CERTIFICATE OF APPROPRIATENESS

Property: 2006 Decatur Street, Lot 5, Block 418, Baker W R NSBB Subdivision. The property includes a historic 1,080 square foot, one-story wood frame single-family residence and detached garage situated on a 5,000 square foot (50' x 100') interior lot. The detached garage is not classified in the building inventory.

Proposal: Alteration – Revision. The rotation and alteration of the existing structure was approved in January 2016. The approved COA included altering the façade of the existing structure to restore the structure to an appearance more compatible with the original pre-1900 style and design.

EAST SIDE ELEVATION

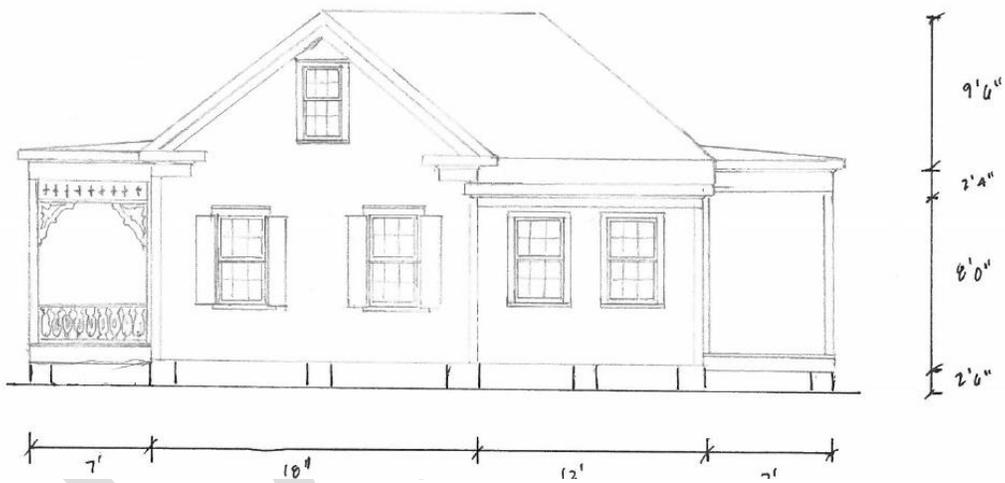
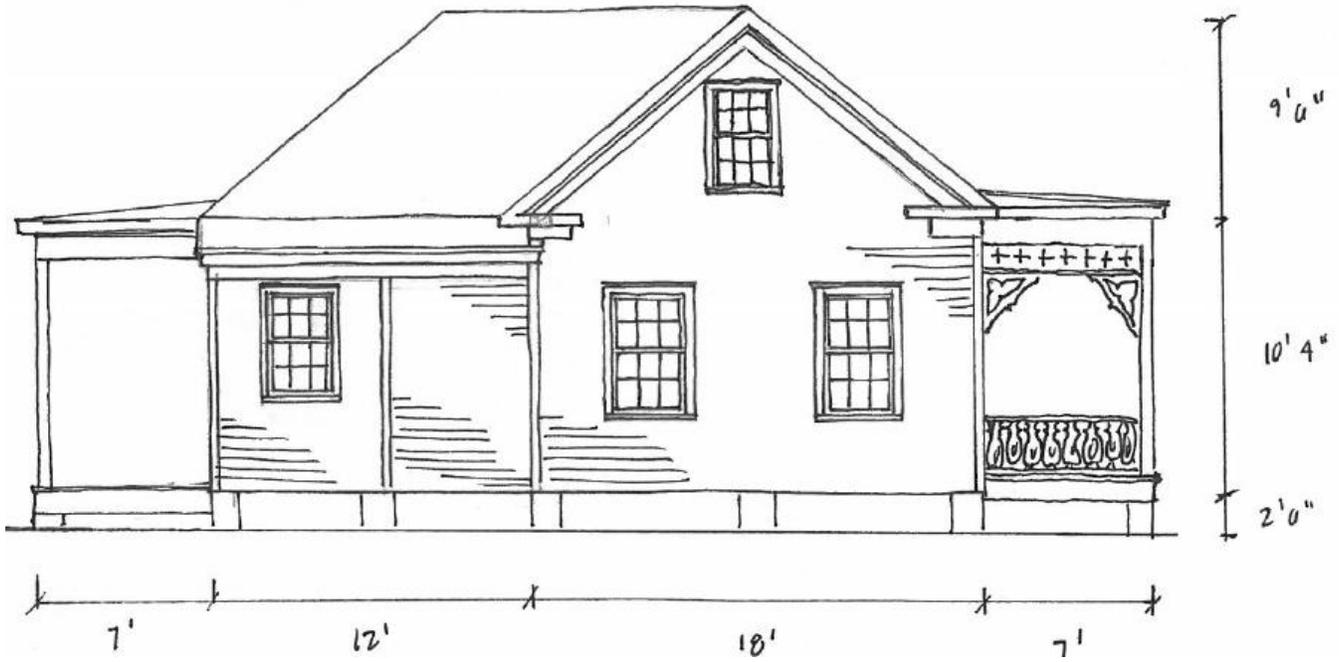
Proposed June 2016: The existing rotated front porch will no longer be enclosed and will be reconstructed. All other aspects of this elevation are to remain as approved. The porch will feature a door and window on this elevation. See drawings for more detail.

NORTH (REAR) ELEVATION

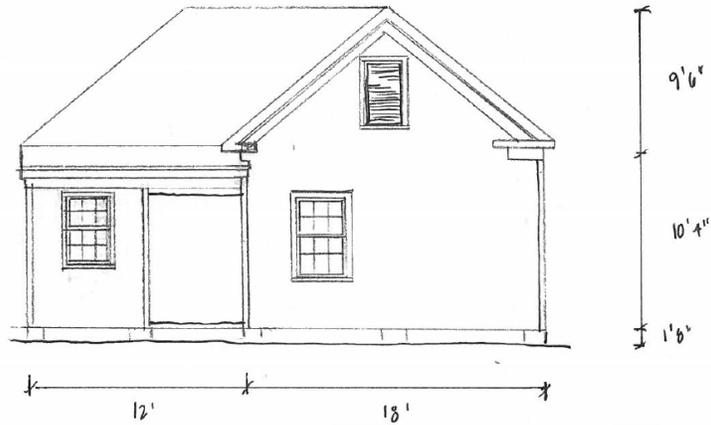
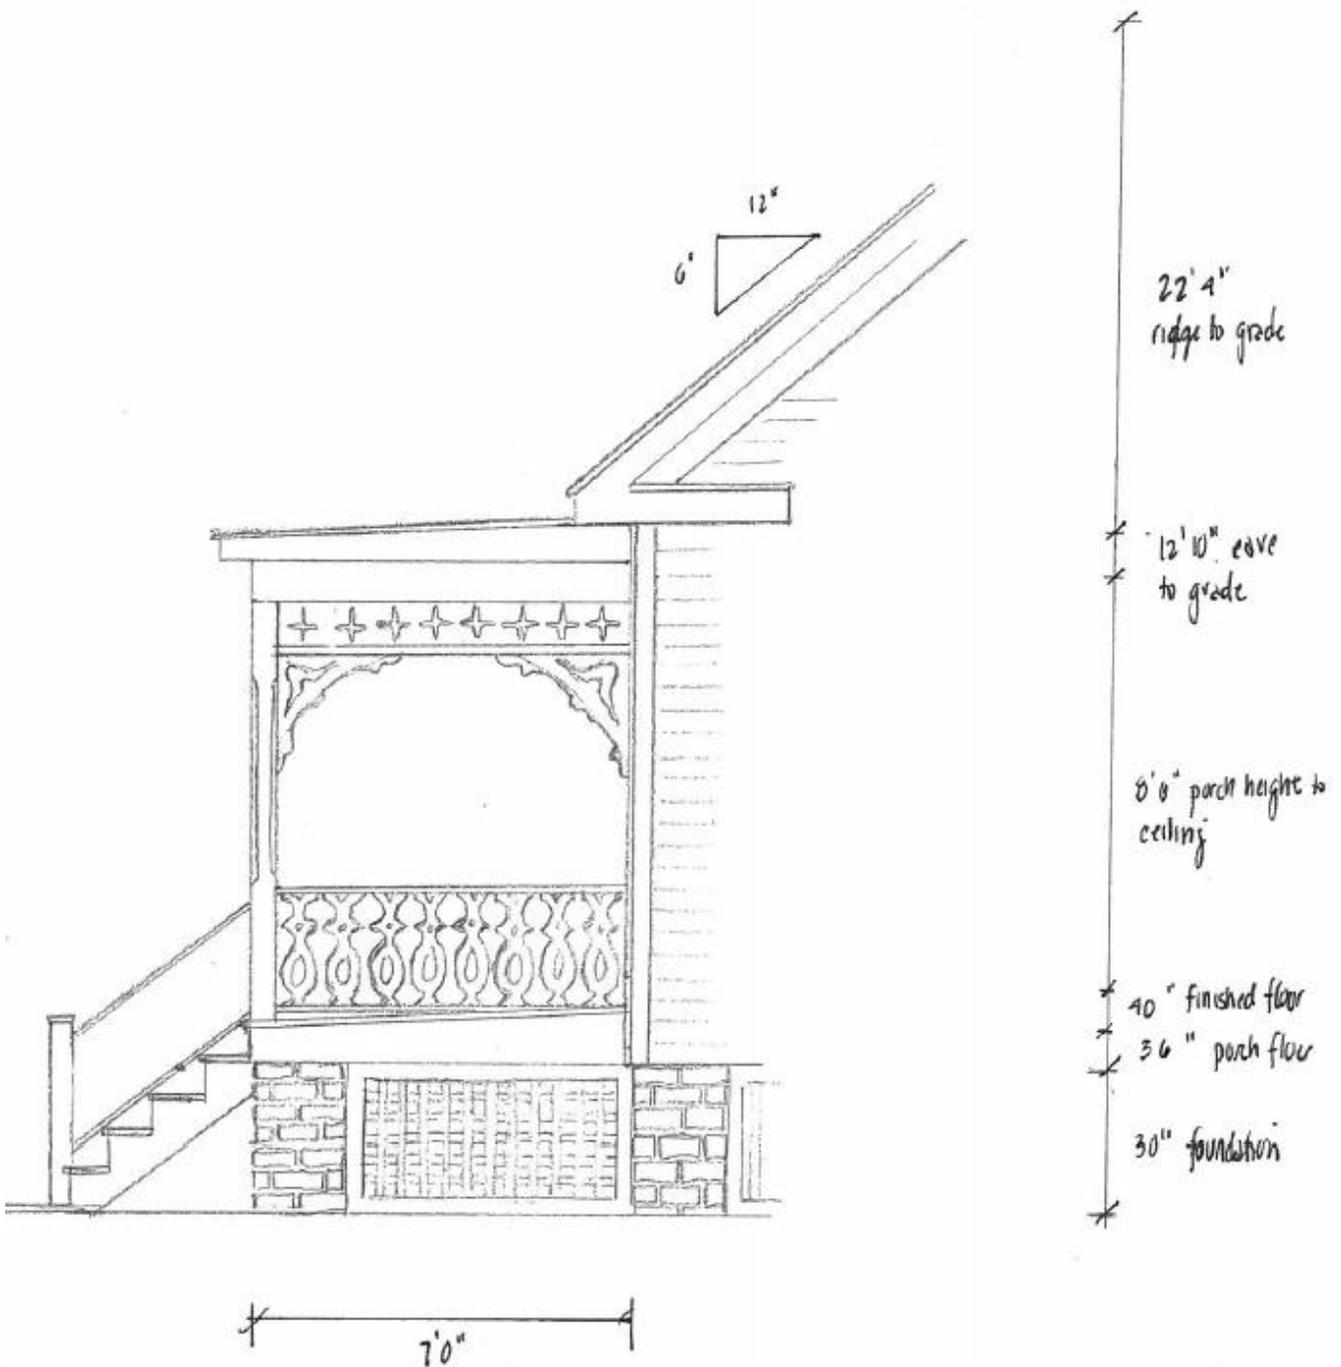
Proposed June 2016: The existing rotated front porch will no longer be enclosed and will be reconstructed. All other aspects of this elevation are to remain as approved. The porch will feature a door on this elevation. See drawings for more detail.
